PCN – Process Change Notification

Change:	MA700.A.ABC.001	
Date:	2017/12/26	
Author	Rachel Wu

Model#	Part Number	Changes
MA700 Pantheon 3in1 Screwmount Antenna GPS-Glonass 3M RG174 SMA(M) ST 2.4/5.8GHz 3M CFD-200 SMA(M) ST Cellular 3M CFD-200 SMA(M) ST	MA700.A.ABC.001	 Modify the title. Add the Barcode label and amend the Label. Amend heat shrink tube tolerance. Amend tolerance. Modify the label material. Modify the Washer and Nut material.

Illustration of Change Old Drawing

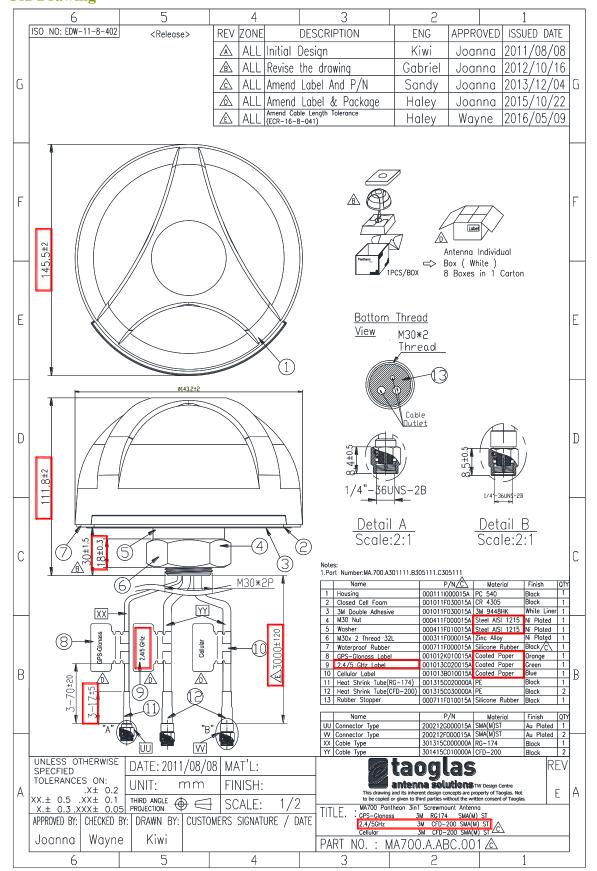
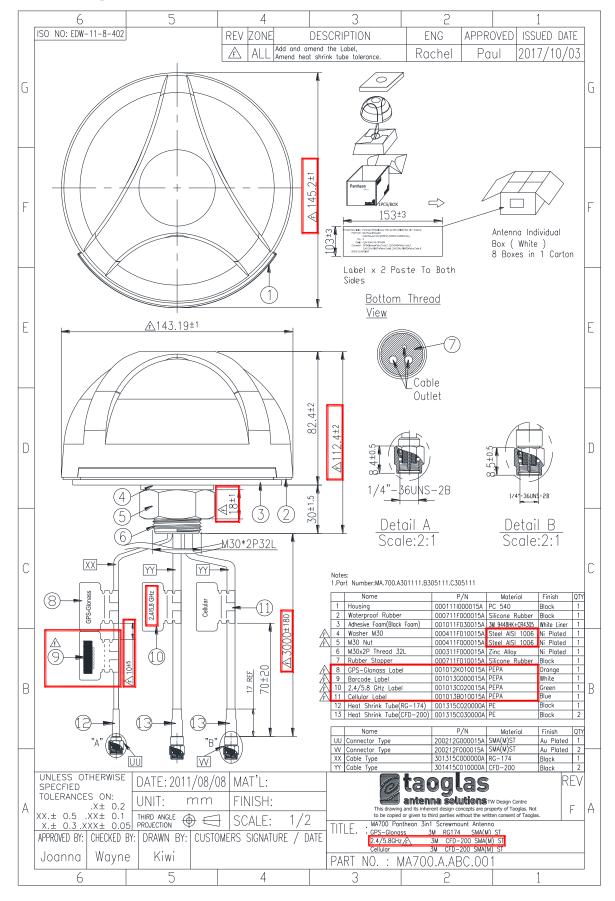
- 1. Modify the title. (2.4/5 GHz ->2.4/5.8 GHz)
- 2. Add the Barcode label and amend the Label. (2.4/5 GHz->2.4/5.8 GHz)
- 3. Amend heat shrink tube tolerance. (17±5->17 REF)
- 4. Amend tolerance. (145.5±2->145.5±1 & 111.8±2->112.4±2 & 18±0.3->18±1)
- 5. Modify the label material. (Coated Paper->PEPA)
- 6. Modify the Washer and Nut material. (Steel AISI 1215->Steel AISI 1006)
